The Station at Riverside

MASTER PLAN

ISSUES:

MASTER PLAN : Beneficial Open Space > 15%

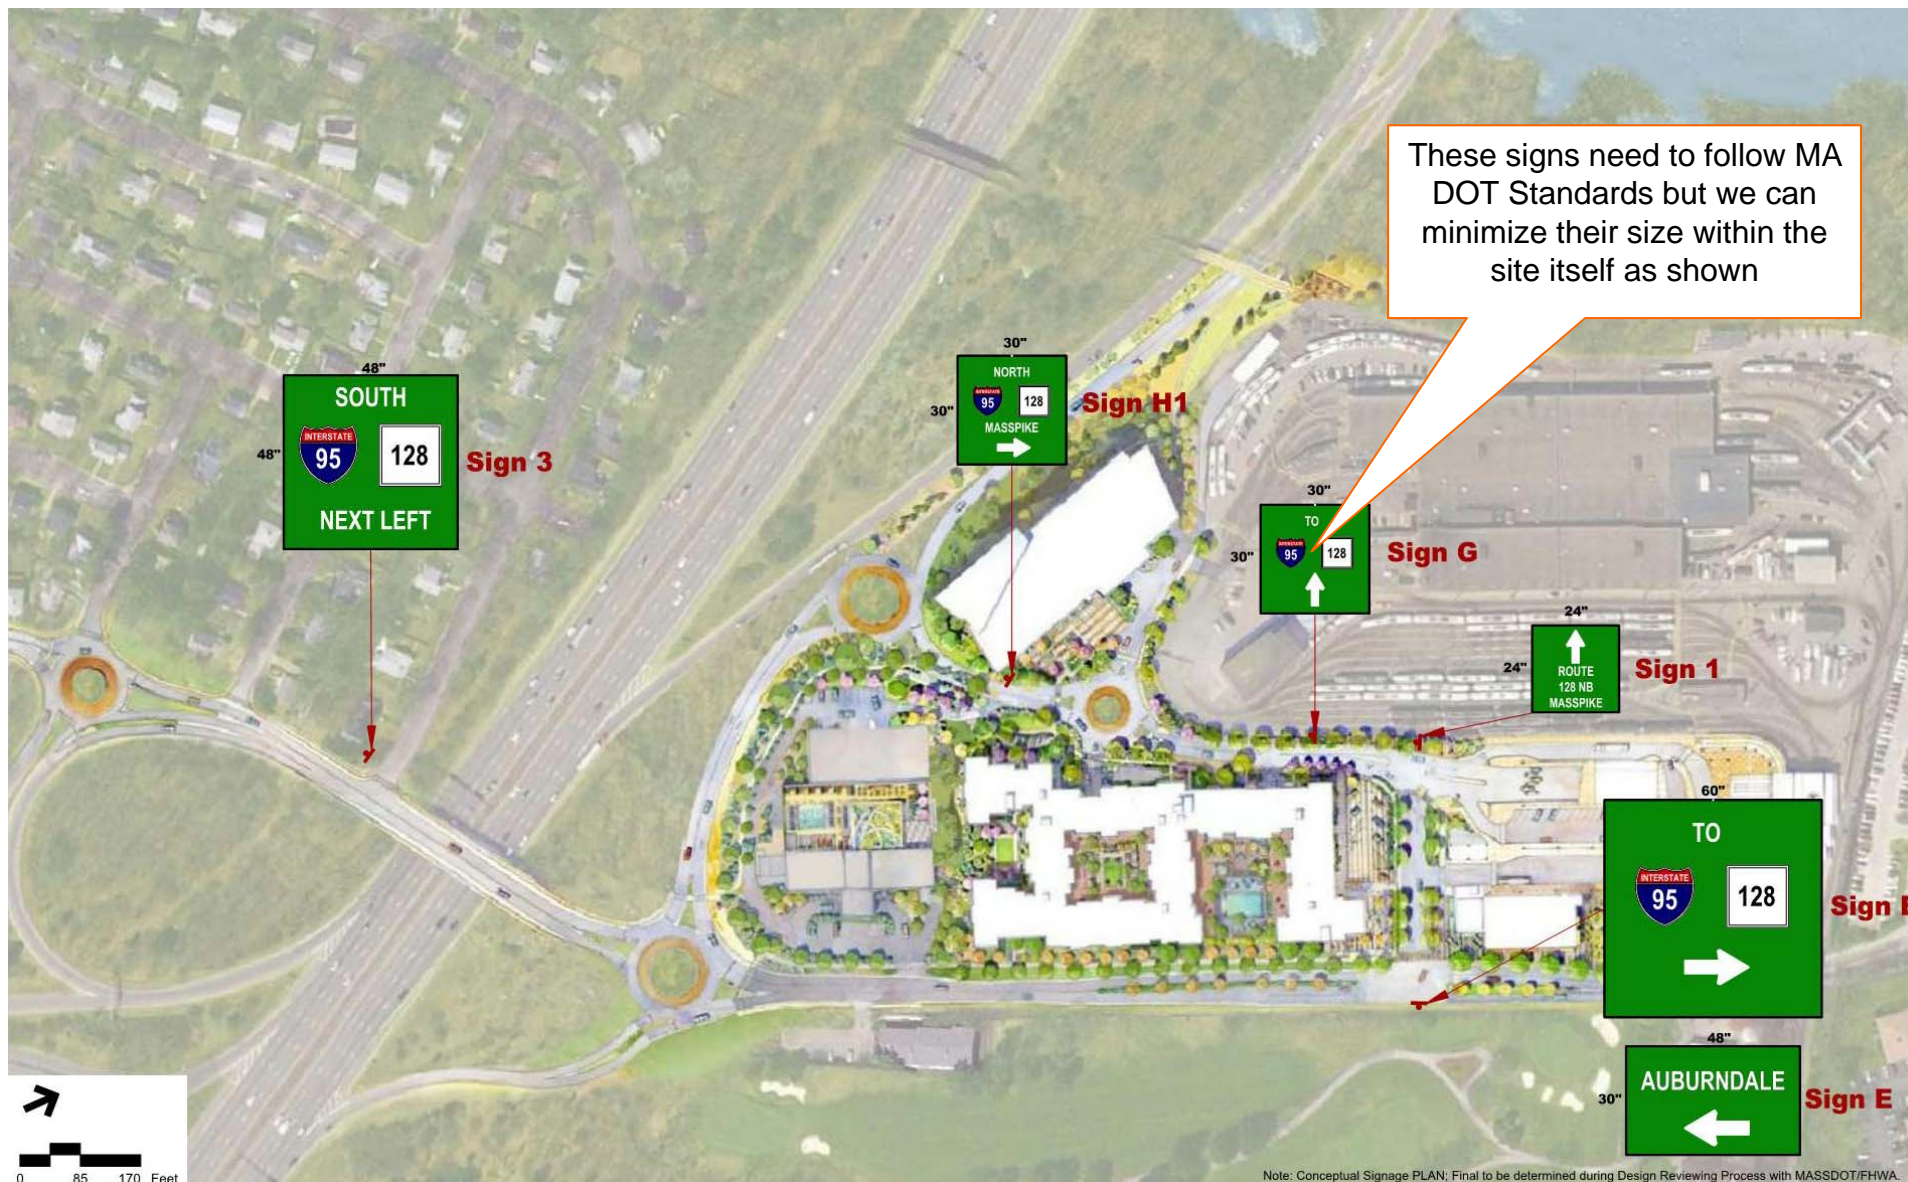
The office trellis area was not counted in the calculation for beneficial open space

The dog park and green space here are also additional

The area in front of the retail building is additional

Ground Floor

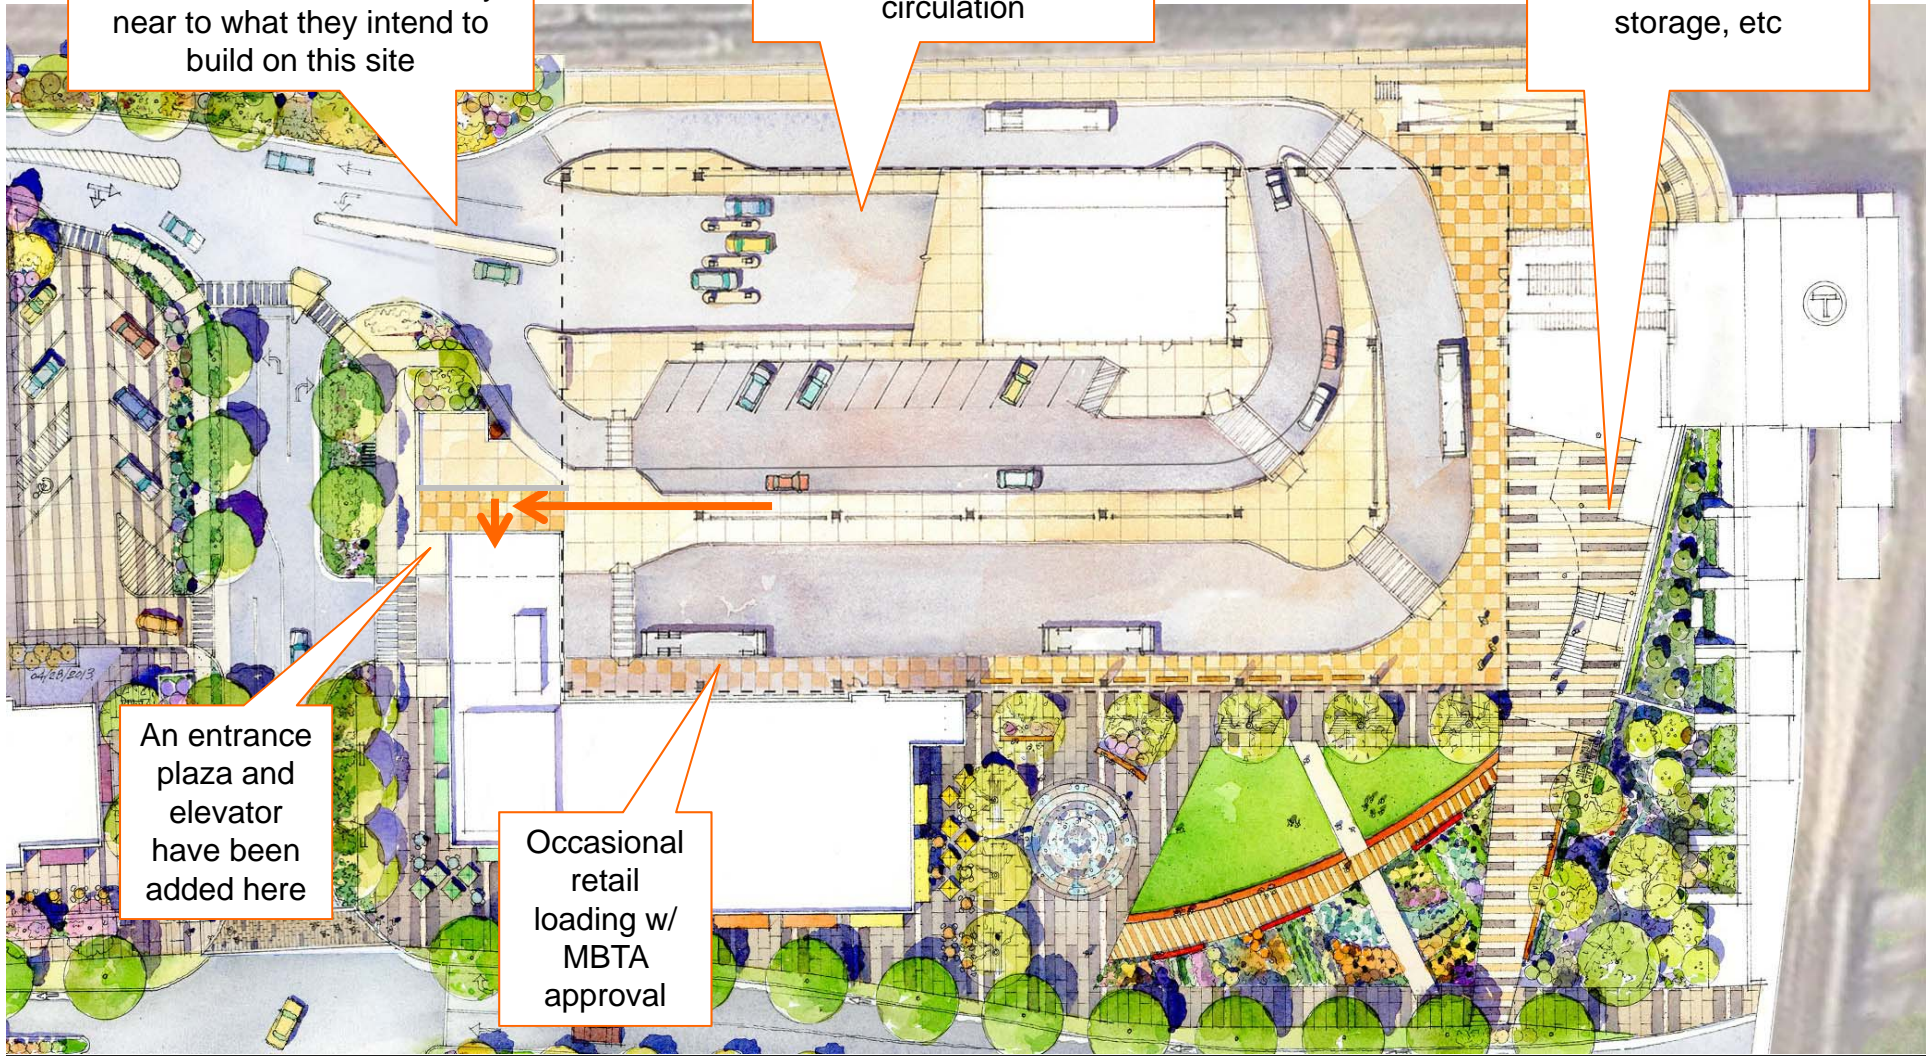
- That what is planned is close to what will actually be built
- That loading for the retail is allowed by the MBTA
- That pedestrian circulation works well through and around the garage

Addition to existing station contains elevators, stairs, bike storage, etc

An entrance plaza and elevator have been added here

Occasional retail loading w/ MBTA approval

RIVERSIDE RESIDENTIAL : Open Space along Grove St.

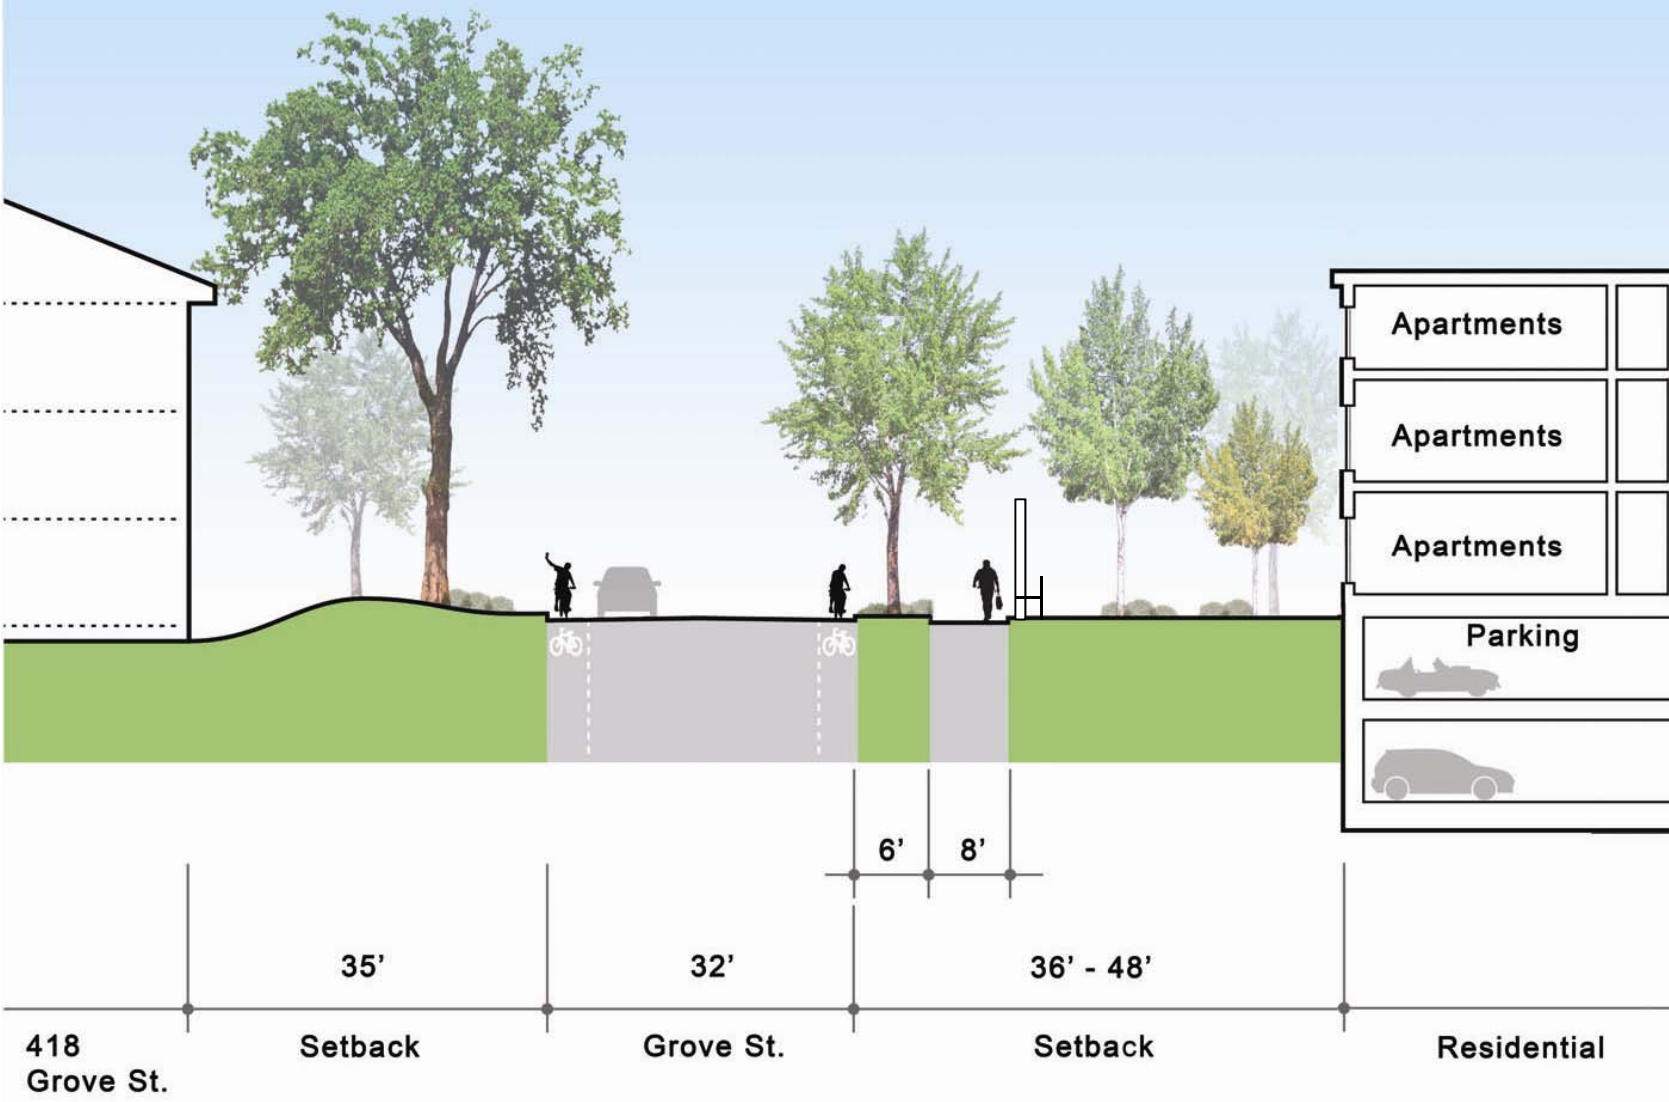
Beneficial Open Space along Grove St.

- Explain in more detail benches, lighting, planting, etc.

Public benches and lighting spaced evenly along the 8' sidewalk parallel to Grove Street

Between 36' and 48' of planting dimension

RIVERSIDE OFFICE : Potential Access to Charles River Basin

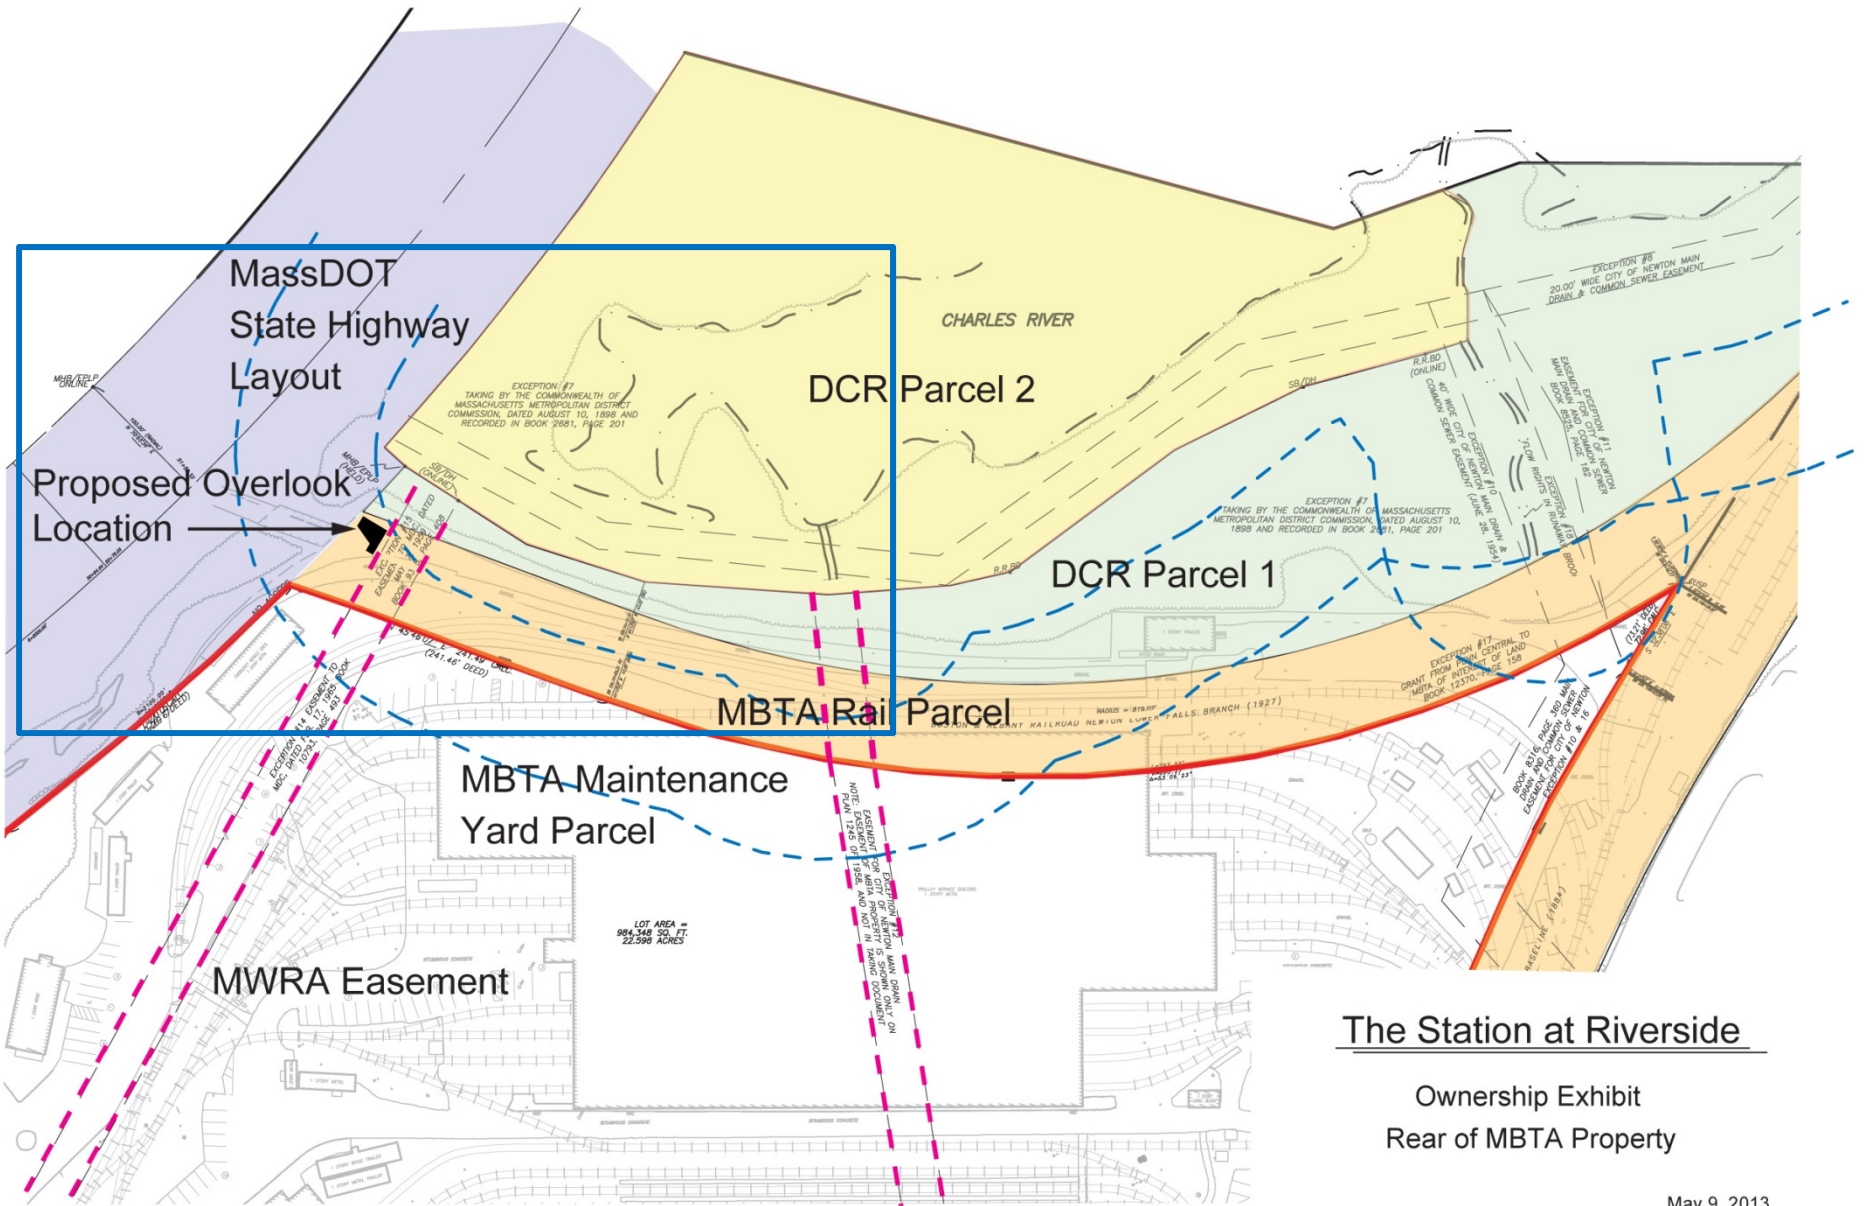
Landscape design

- Path materials
- Size and location of platform

Potential connection to Charles River Basin

MBTA fence line will be shifted to allow for accessible path to the outlook.
